New Jersey Turnpike Authority

Document Change Announcement

Electrical Qualification Criteria Updates

DCA2024SD-01

LIGHTING STANDARD KEY SHEET

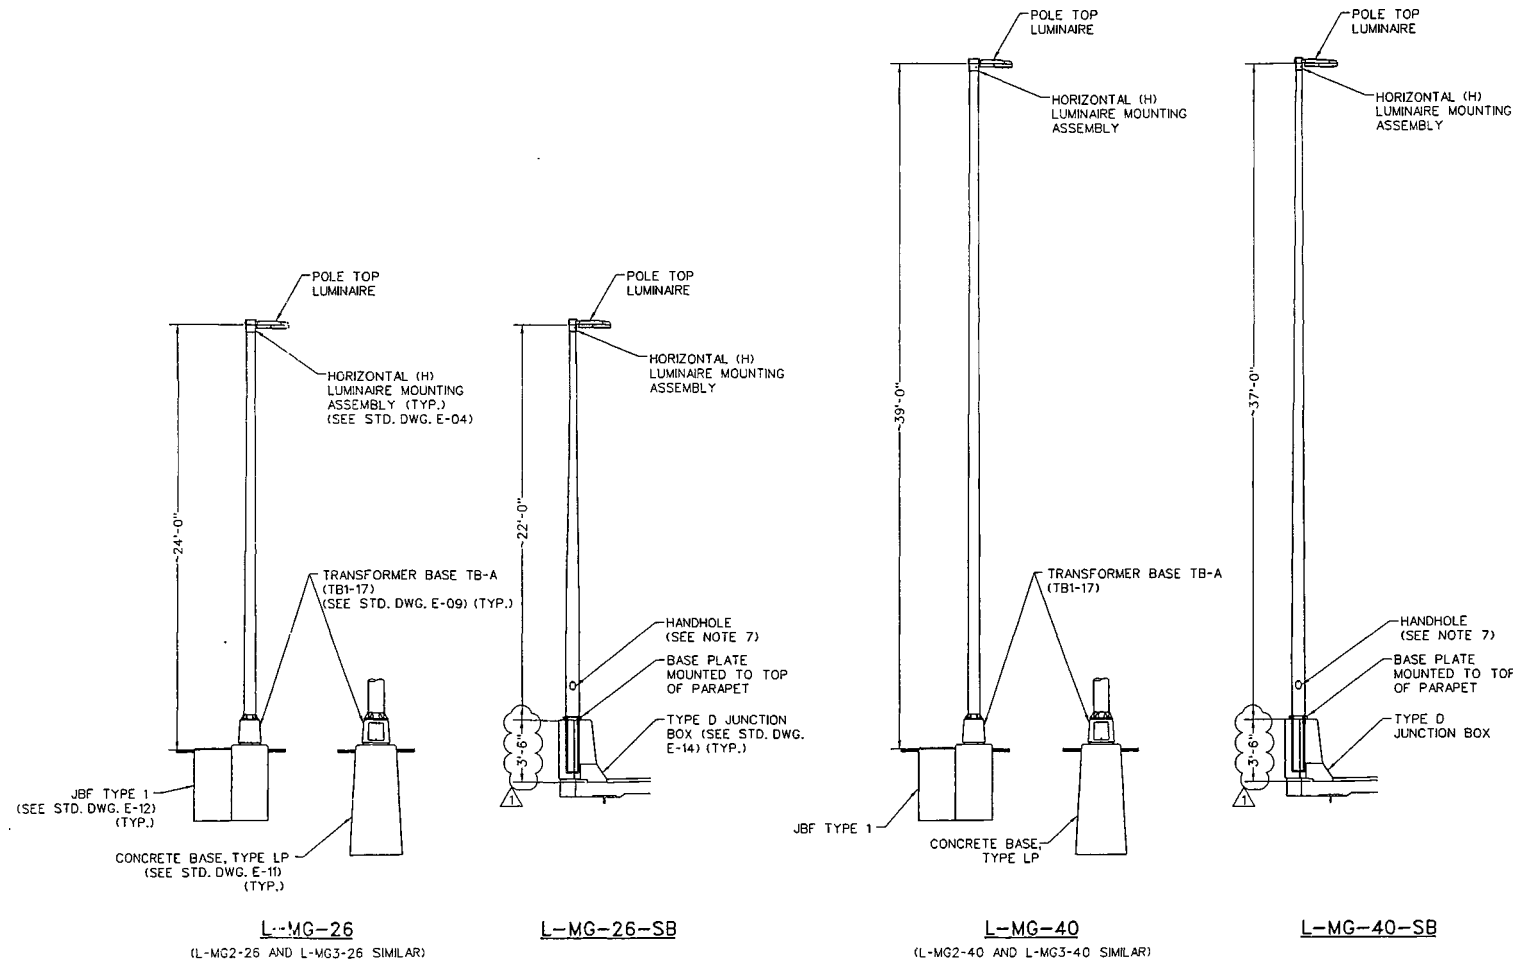
1	DIMENSION & LUMINAIRE TYPES	01/24
0	REISSUED DRAWING	09/21
REV.	DESCRIPTION	DATE

TYPE H POLE-TOP LUMINAIRE MOUNTING ASSEMBLIES

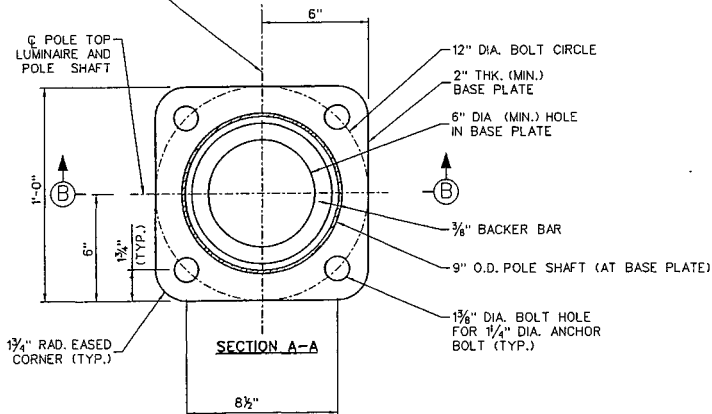
1	ADDED NOTE	01/24
0	REISSUED DRAWING	09/2
REV.	DESCRIPTION	DATE

8. ALL HARDWARE SHALL BE STAINLESS STEEL GRADE 304 OR BETTER, UNLESS OTHERWISE NOTED.
9. WHEN HORIZONTAL MOUNTING ADAPTERS ARE USED TO INSTALL THE GALLEON FIXTURE, A THROUGH BOLT SHALL BE INSTALLED TO SECURE NAST ARM ADAPTER AND TENON. TENON REQUIRES A HOLE FOR 3/4"-16 STAINLESS STEEL HEX HEAD BOLT WITH LOCK WASHER AND DOUBLE NUT, LENGTH AS REQUIRED. THE TENON ADAPTER MAY BE MANUFACTURED WITH THIS HOLE OR THE HOLE MAY BE FIELD-DRILLED.

STEEL LIGHTING STANDARD

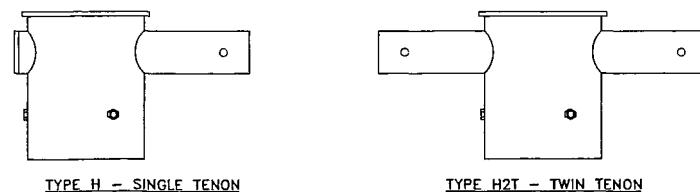
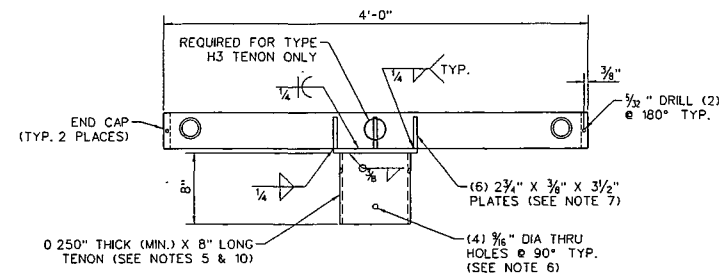
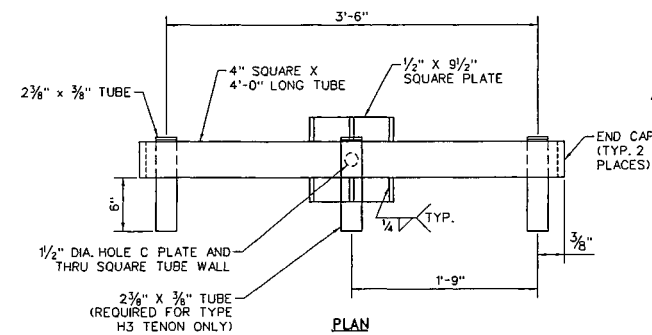
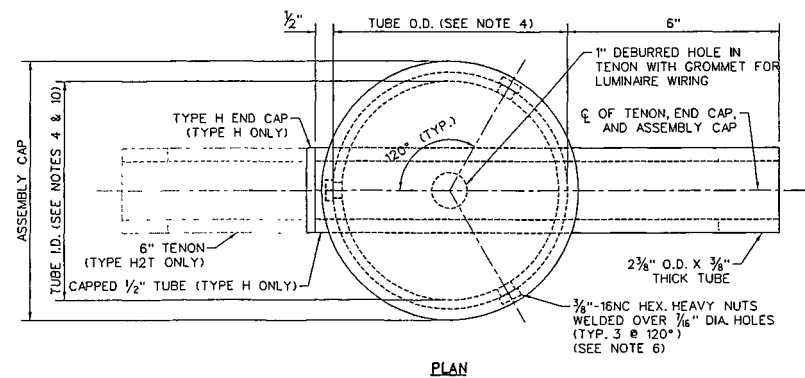
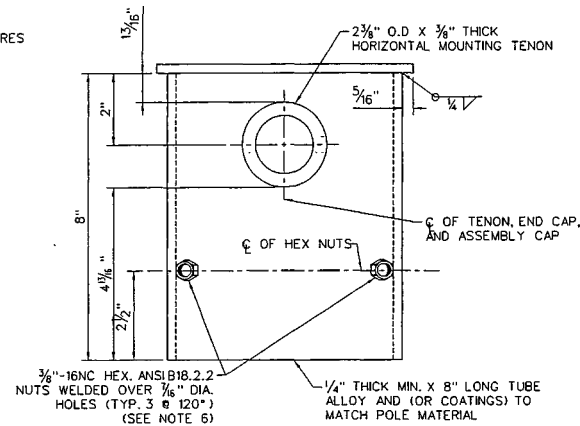
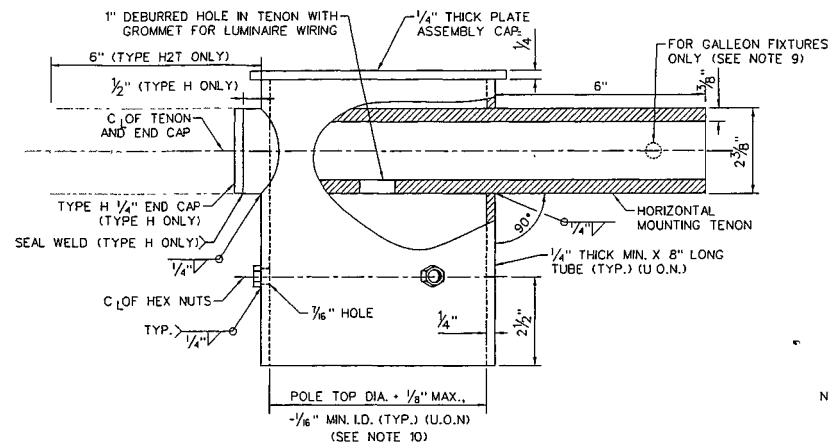
1	UPDATED HANDHOLE & NOTE	01/24
0	REISSUED DRAWING	09/21
REV.	DESCRIPTION	DATE

17. A HANDHOLE IS REQUIRED ON ALL BRIDGE-MOUNTED LIGHTING STANDARDS AND SHALL BE LOCATED SUCH THAT THE VERTICAL CENTERLINE OF THE HANDHOLE IS 18" FROM TOP OF PARAPET. WHEN LOCATED BEHIND CHAIN LINK FENCE, THE BOTTOM OF THE HANDHOLE SHALL BE LOCATED ONE FOOT ABOVE THE FENCE. ATTACHMENT SCREWS SHALL BE COATED WITH AN APPROVED ANTI-SEIZE COMPOUND.

**TYPE V POLE-TOP LUMINAIRE
MOUNTING ASSEMBLIES**

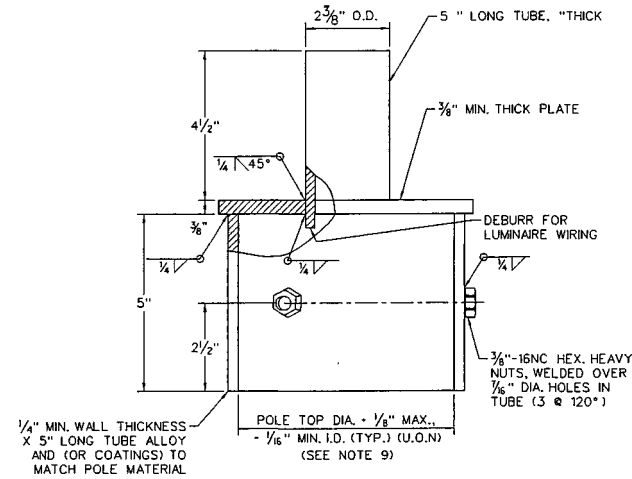
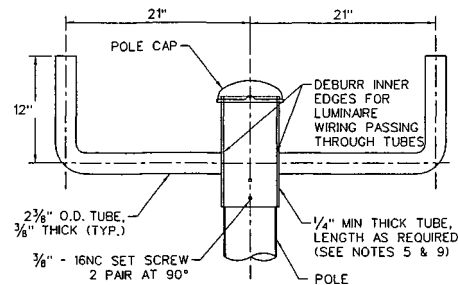
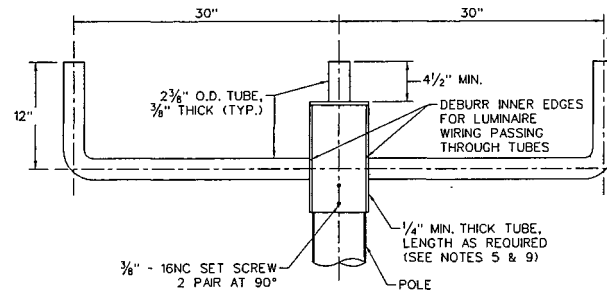
1	ADDED NOTE	01/24
0	REISSUED DRAWING	09/21
REV.	DESCRIPTION	DATE

- (4) 1/2" LOCKWASHER, FLATWASHER, AND SCREWS
- NOT ALL LUMINAIRES MAY BE MOUNTED ON VERTICAL ADAPTORS. SEE SPECIFIC MANUFACTURER MOUNTING DIRECTIONS FOR OPTIONS.

NEW JERSEY TURNPIKE AUTHORITY NEW JERSEY TURNPIKE GARDEN STATE PARKWAY STANDARD DRAWINGS		
HIGHMAST LIGHTING STANDARD DETAILS - 2		
OFFICE OF THE CHIEF ENGINEER NEW JERSEY TURNPIKE AUTHORITY WOODBRIDGE NEW JERSEY	STANDARD DRAWING E-07

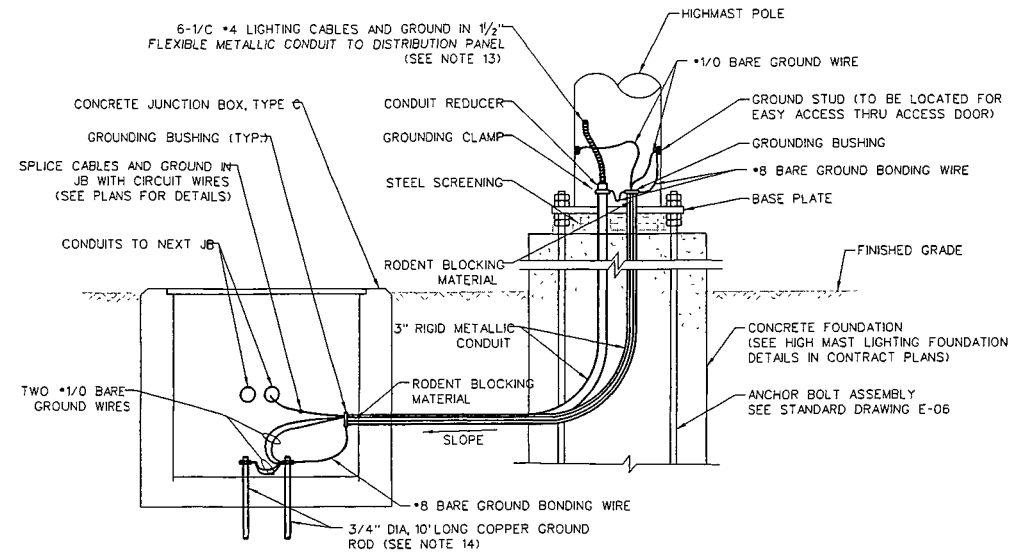
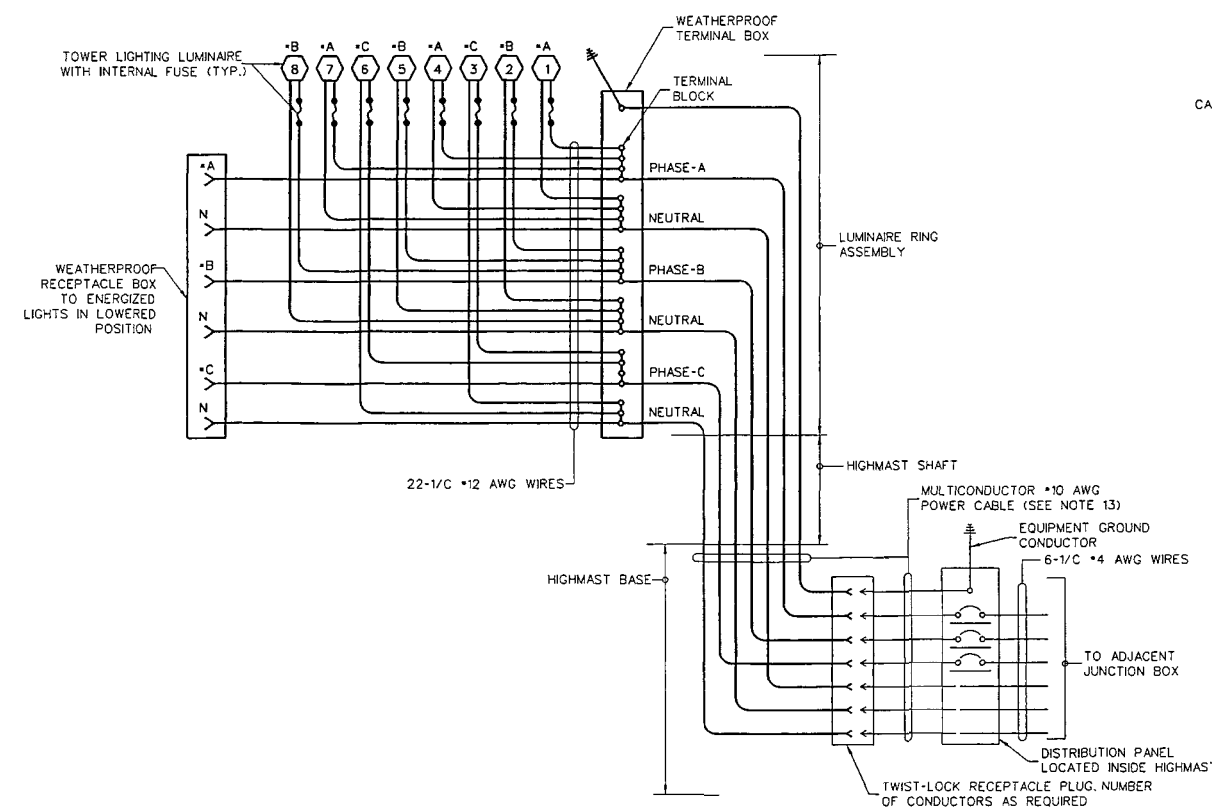
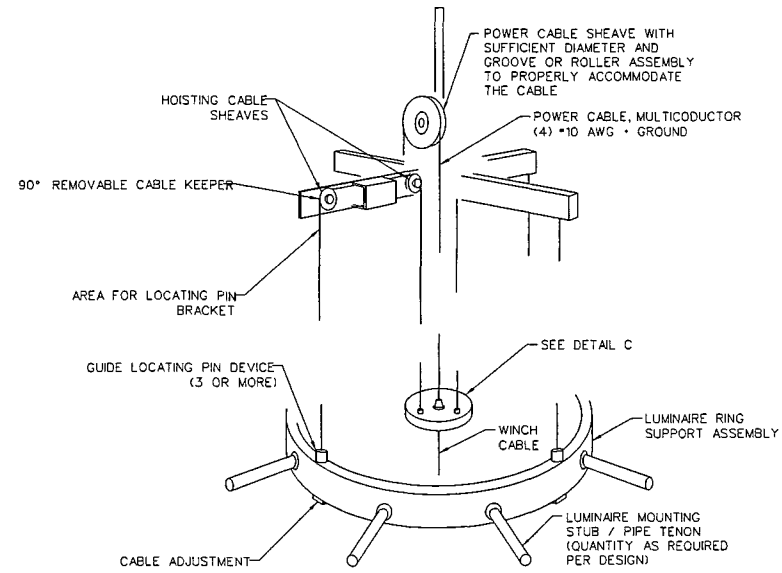
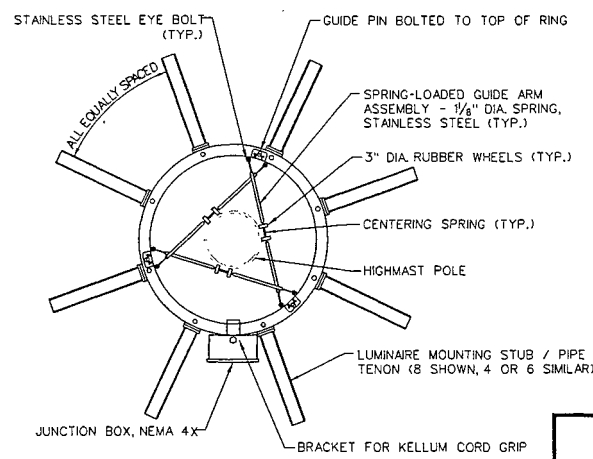
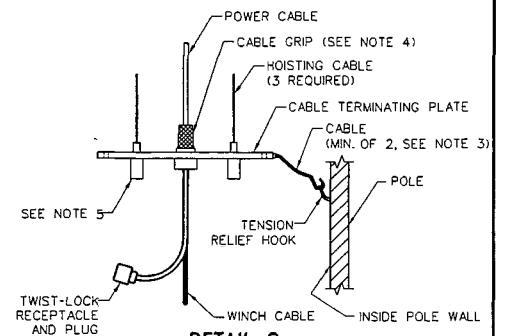
1	ADDED NOTE FOR PLACEMENT	01/24
0	REISSUED DRAWING	09/21
REV.	DESCRIPTION	DATE

- GROUND RODS SHALL BE INSTALLED IN ACCORDANCE WITH NEC RECOMMENDATIONS.
 - REFER TO STANDARD DRAWING GR-10 FOR CLEARANCE REQUIREMENTS BEHIND GUIDE RAIL WHERE PRESENT.

CONCRETE BASE, TYPE LP

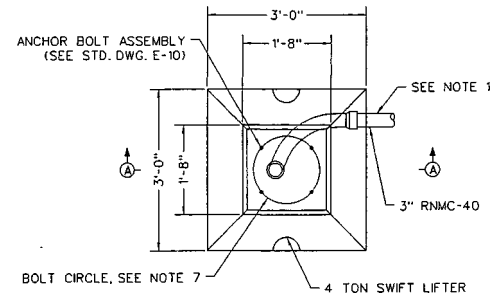
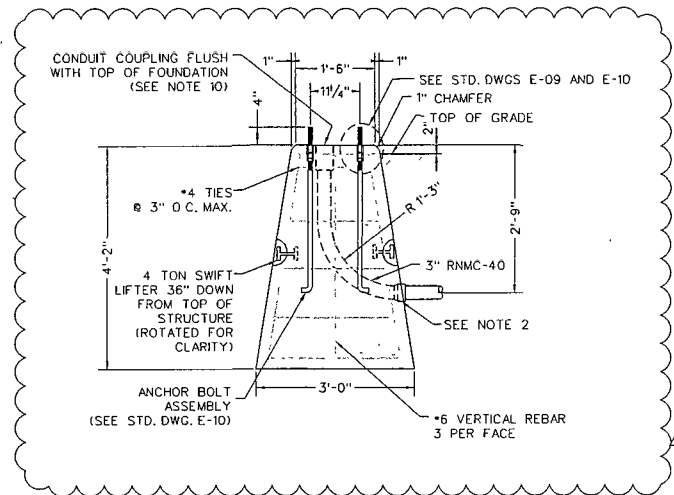
1	UPDATED LIGHT POLE BASE LP	01/24
0	REISSUED DRAWING	09/21
REV.	DESCRIPTION	DATE

JUNCTION BOX TYPE C

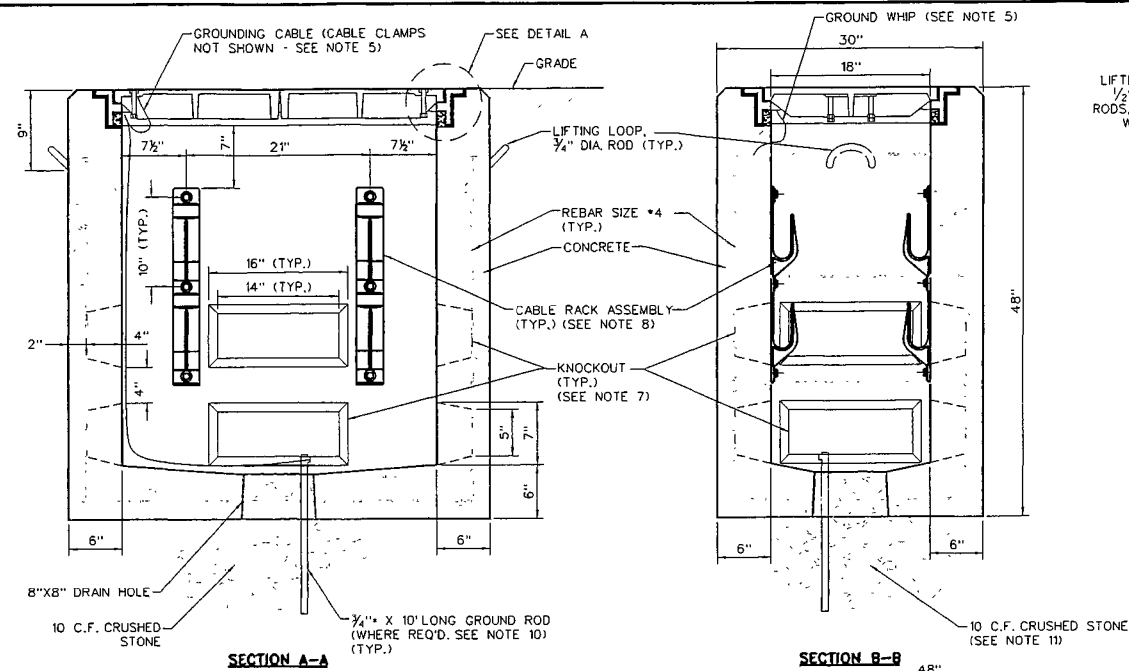
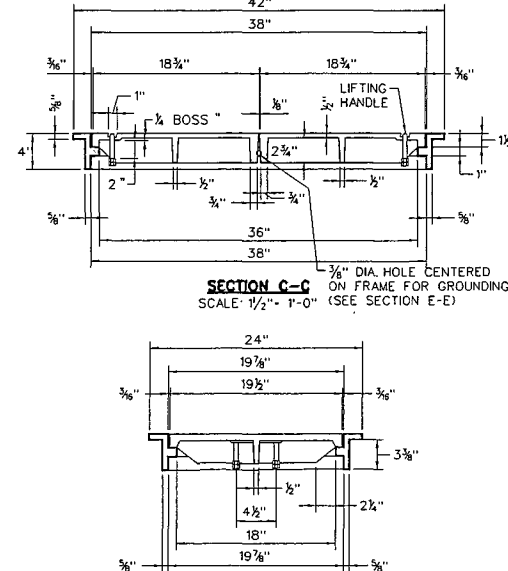
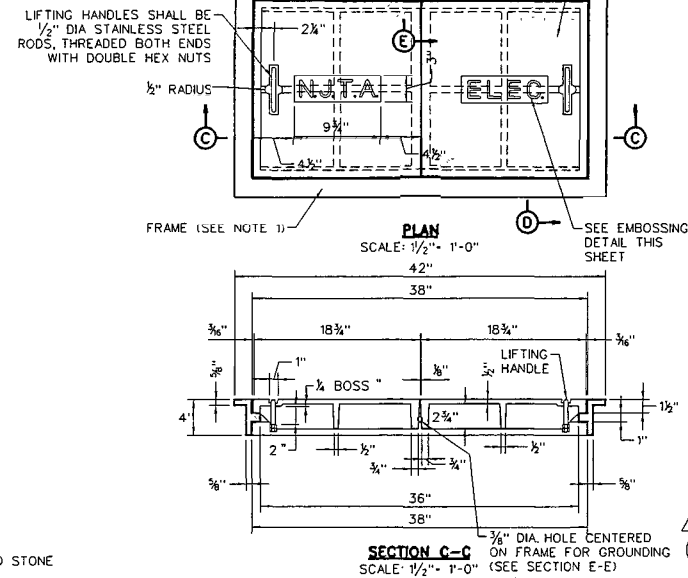
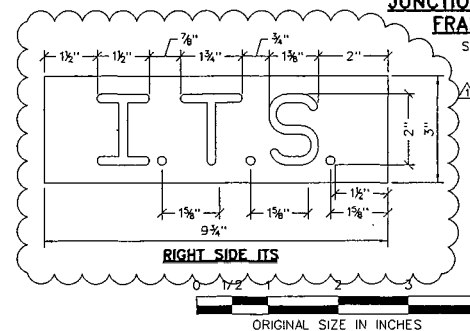
1	ADDED ITS EMBOSSING, EDIT NOTE	01/24
0	REISSUED DRAWING	09/21
REV.	DESCRIPTION	DATE

ROADWAY LIGHTING
INSTALLATION DETAILS - 3

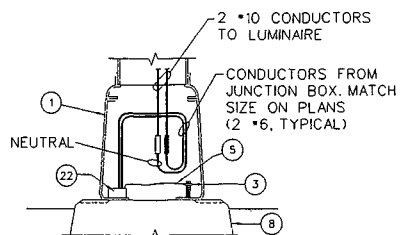
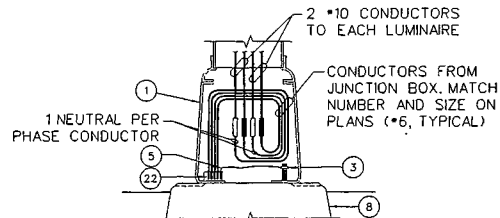
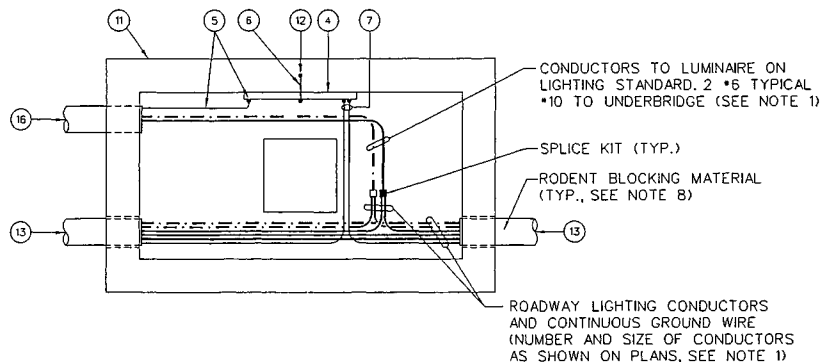
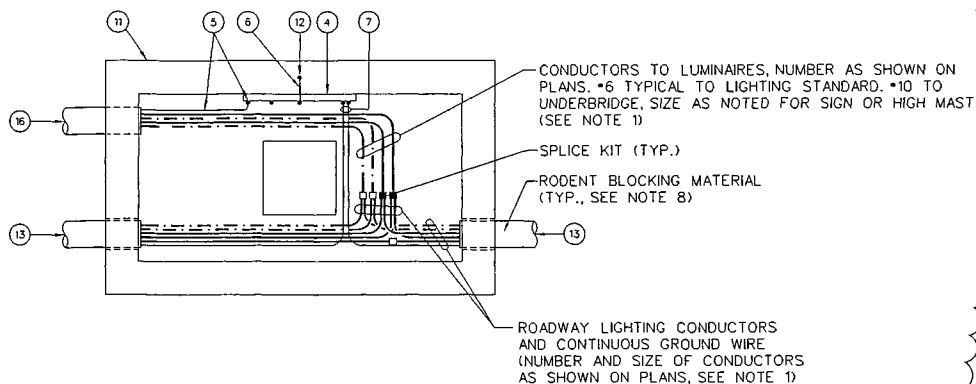
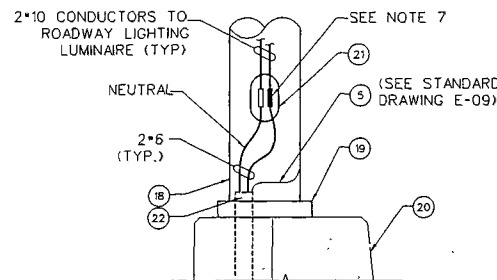
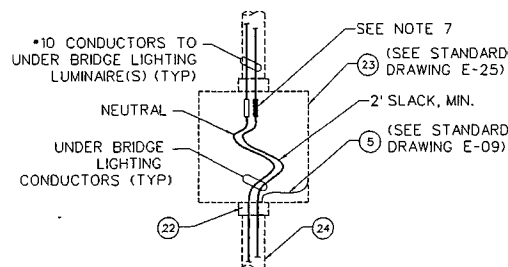
1	REVISED TYPICAL WIRING DETAILS	01/24
0	REISSUED DRAWING	09/21
REV.	DESCRIPTION	DATE
